SIGN IN SHEET
Pre Conference RFQ Replacement of Well #10
Thursday February 20, 2014 @ 11 am with Site Visit to follow

Re: New Well Pump Installation @ Well #10 - North Kingstown, RI

Subject North Kingstown, RI - Well #10

SO: 460378
Model: 12DHHO/5

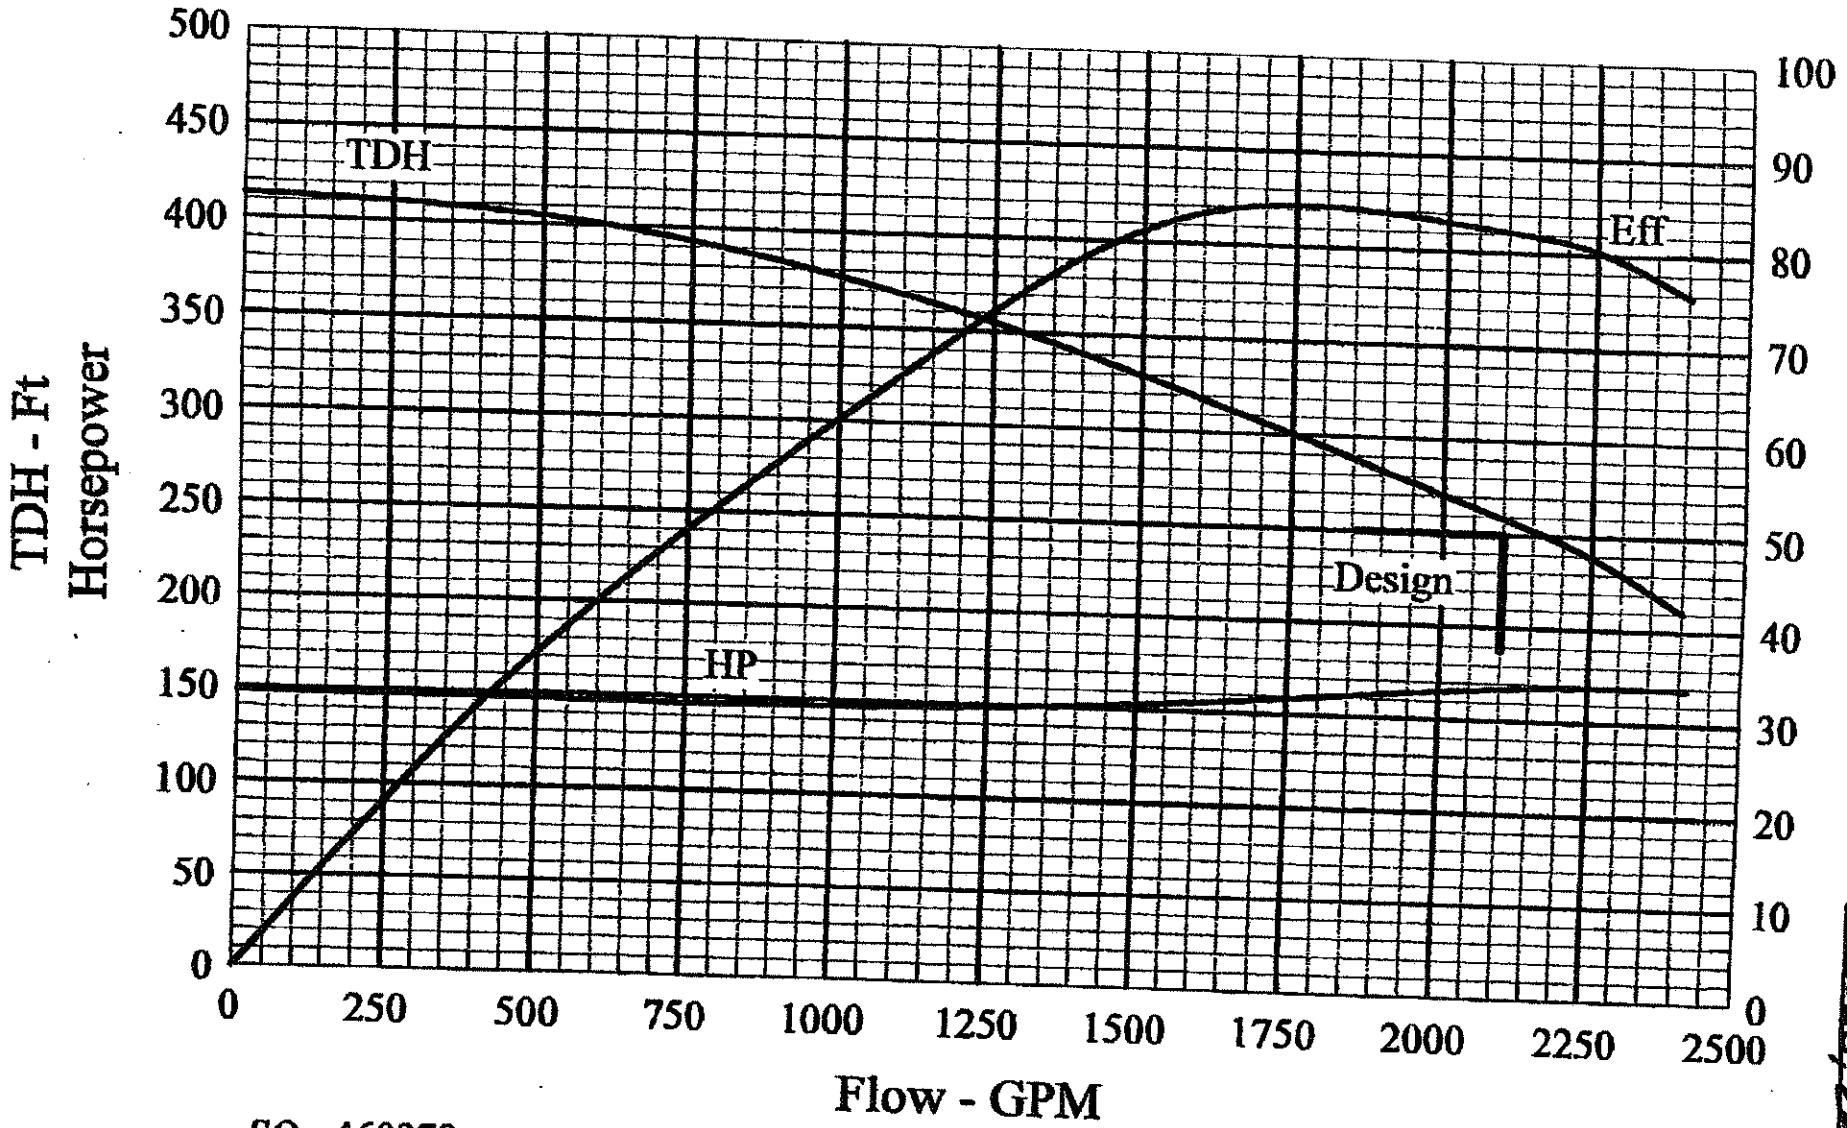
Correct Curve
Tom Hydro

12 DHHO, 5 Stg

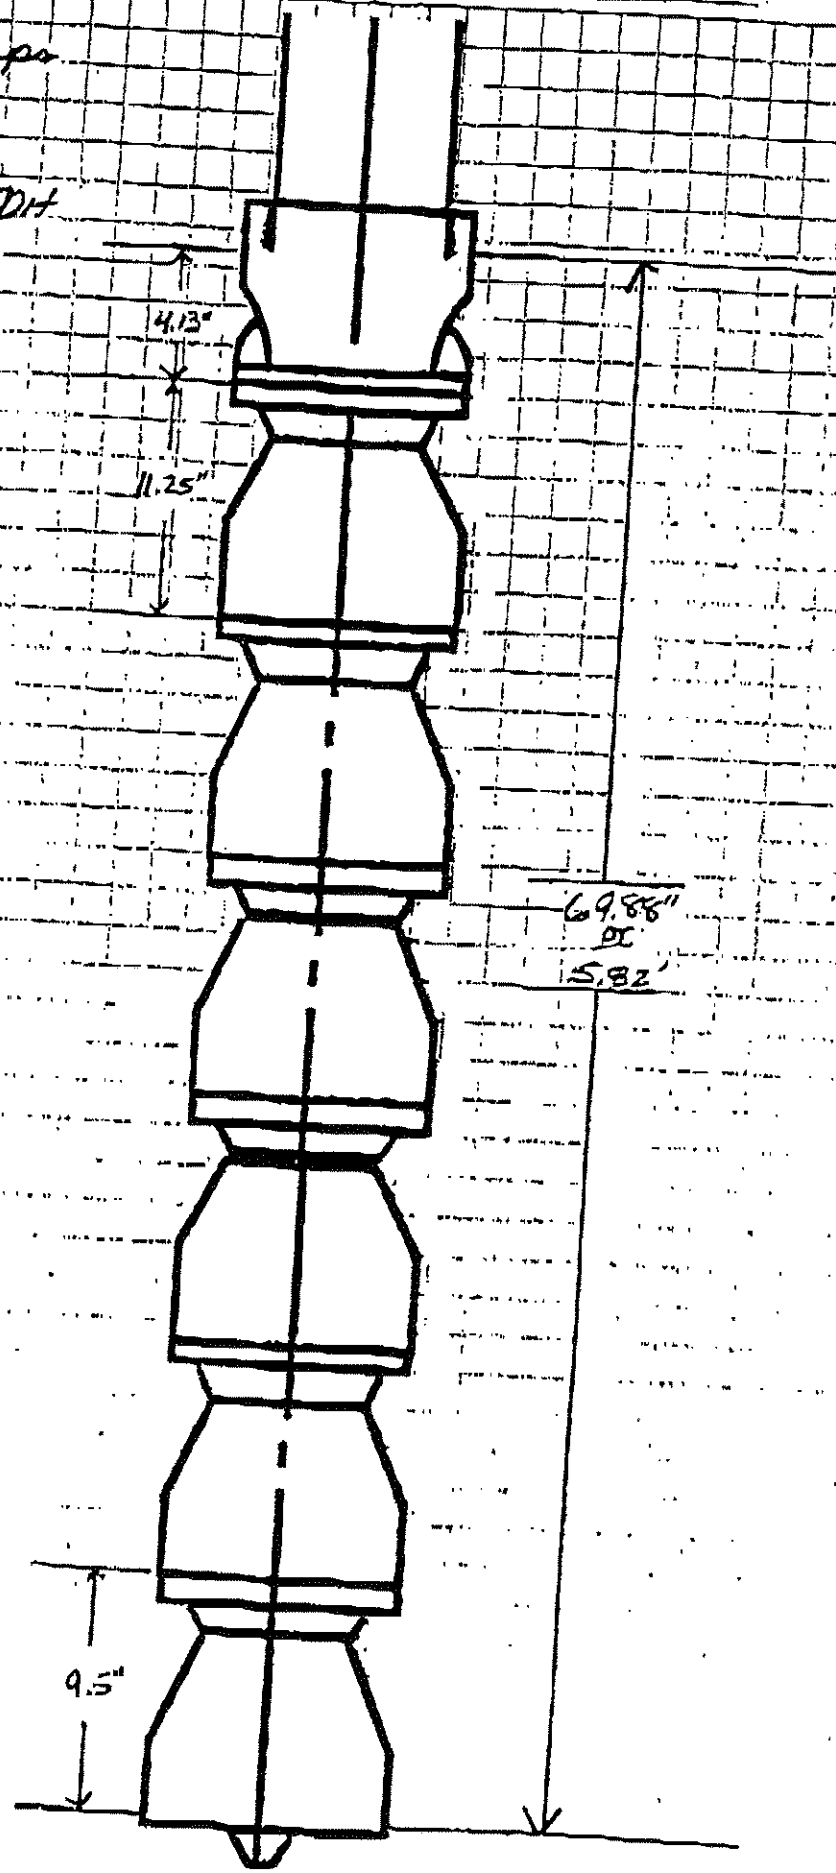
1. A dimensional diagram of the proposed new pump bowl is attached. As the existing discharge head is to be reused no drawing will be provided.
2. A copy of the Operations and Maintenance Manual for the Christensen Pump is attached.

3. The existing discharge head is equipped with a standard packed stuffing box.
4. The O.D. of the Christensen Pump is 11.5-inches and the I.D. of the steel well casing is 12-inches. While this is an extremely tight fit we do not anticipate any problems during installation for several reasons: a) the previous pump bowl was also nominally 12-inch diameter and there was no indication (such as wear on the outside of the bowl) that the pump was in contact with the screen or casing; and b) by reusing the existing discharge head the alignment of the setting should not change.

Well #10 Christensen 12DHHO, 5 stg

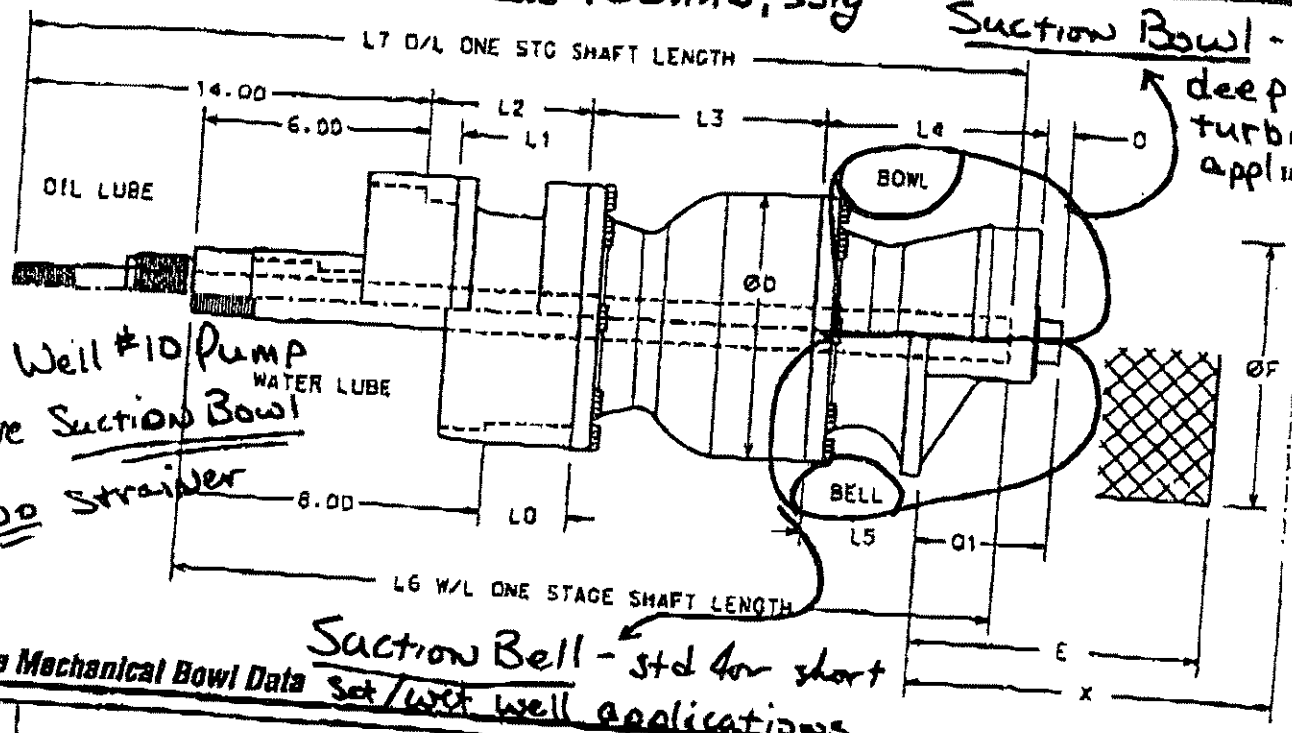
New Well #10 Pump to have Suction Bowl and NO Strainer

1. As the original pumping equipment did not include a suction cone strainer on the intake of the pump bowl, a suction bowl strainer will not be provided for the new bowl assembly. Typically strainers are not used for deep well applications as over time the strainer itself may become encrusted with mineral deposits thereby reducing the flow of water into the pump.

2. The suction case of the proposed new bowl assembly will be a standard deep well turbine pump suction bowl with a female thread at the intake. While the female thread allows for installation of a suction pipe below the bowl assembly no suction pipe is to be provided.
